Request For Information - 065.1

The Cora Apartments (19 W Harrison)

Subject:	**BBQ & Fire Pit at Rooftop Deck**	**Status:**	**Open**
Drawing #:		**Spec Sect #:**	
Addendum:		**Submittal #:**

EXTERIOR ELEVATION 6 SHEET A0304-

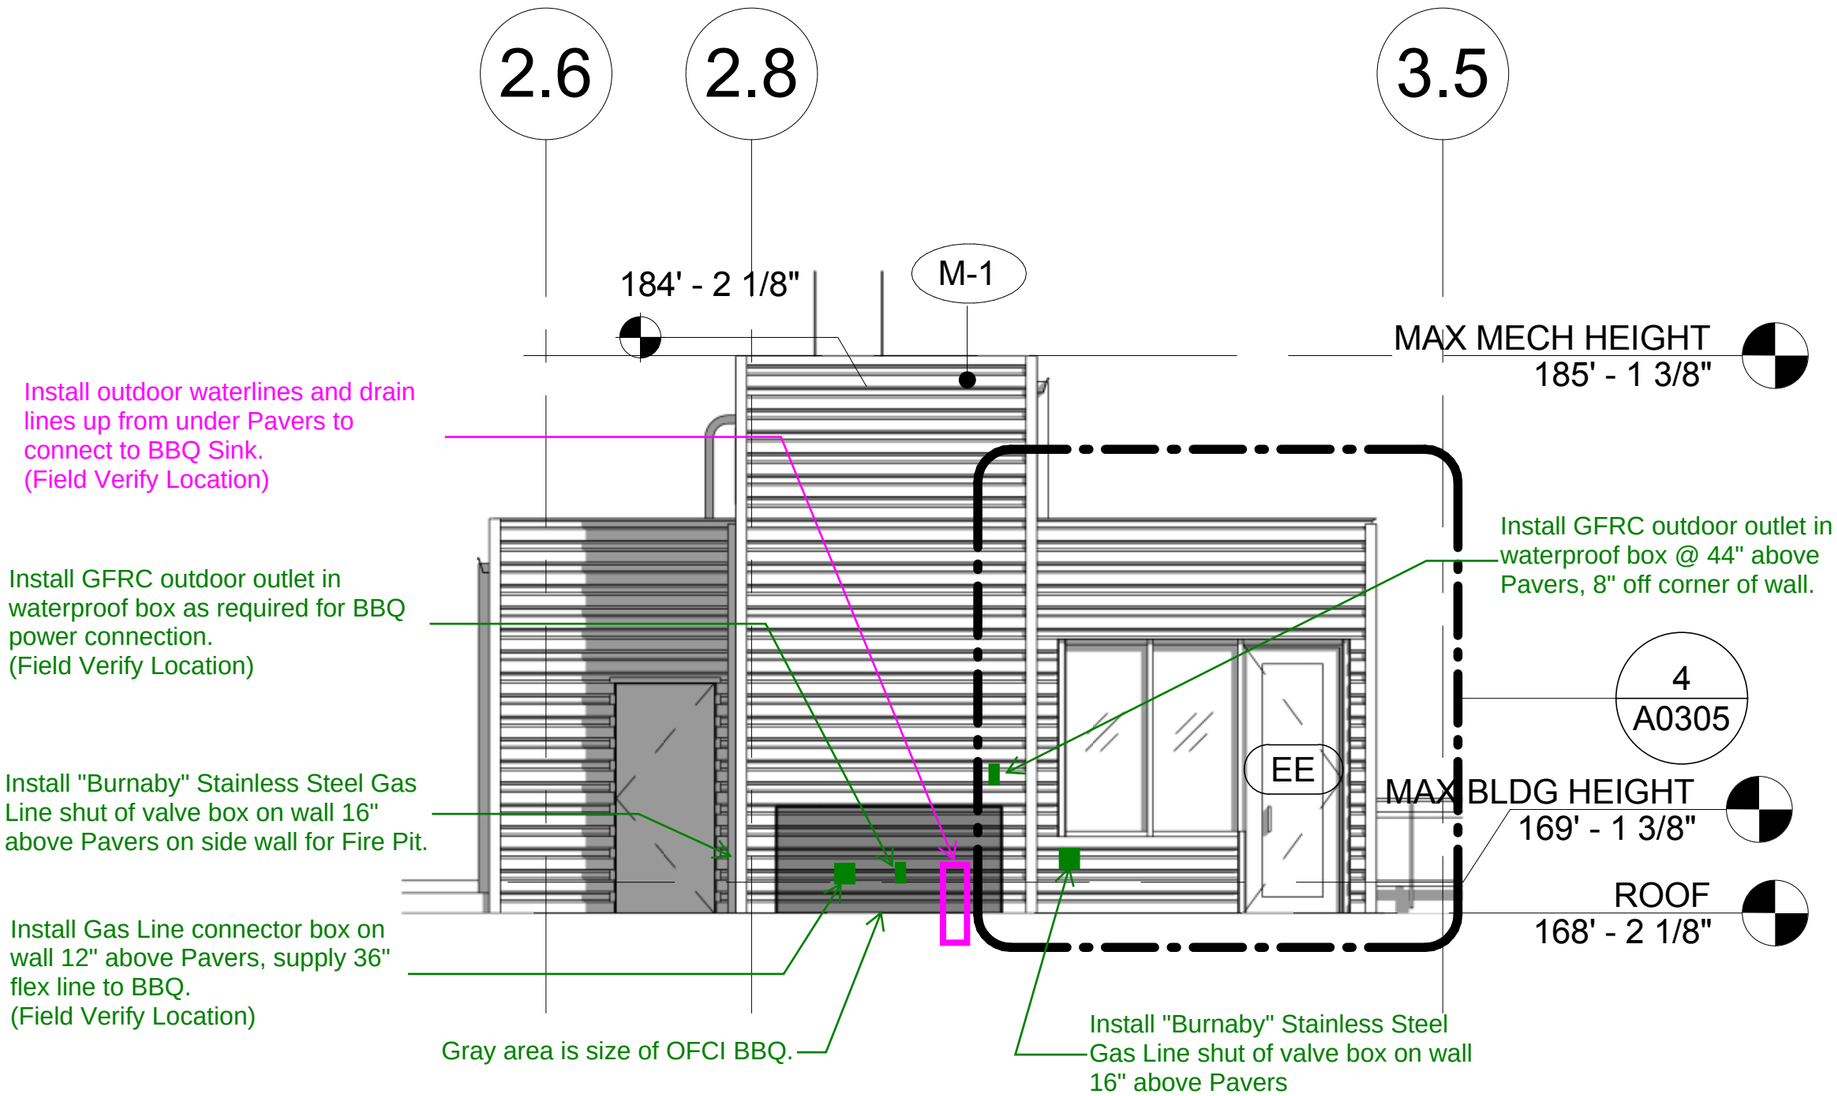
Per the e-mail from John Links, dated 02/01/17, please confirm the "Bull Outdoor Kitchen Grilling Island w/built-in Grill and Sink" is to be installed on the West wall of the elevator vestibule on the rooftop deck, per the attached specs. The installation will include the gas, water connection, the sink shutoffs and drain-down, and the heat trace. Please specify the location of the gas timers for the BBQ and for the Fire Pit on the West wall, and specify whether any GFCI outlets, and/or gas emergency shut-off are desired.

Date	Response
2-2-2017	See attached Roof Top Elevation for recommended locations for Gas valve box and Outdoor outlets, etc. GC and their Subs will need to verify connection points on BBQ when it is on site. JXW

-NO SCALE-
REF: RFI-065.1
JXW
VIA ARCHITECTURE
2-2-2017
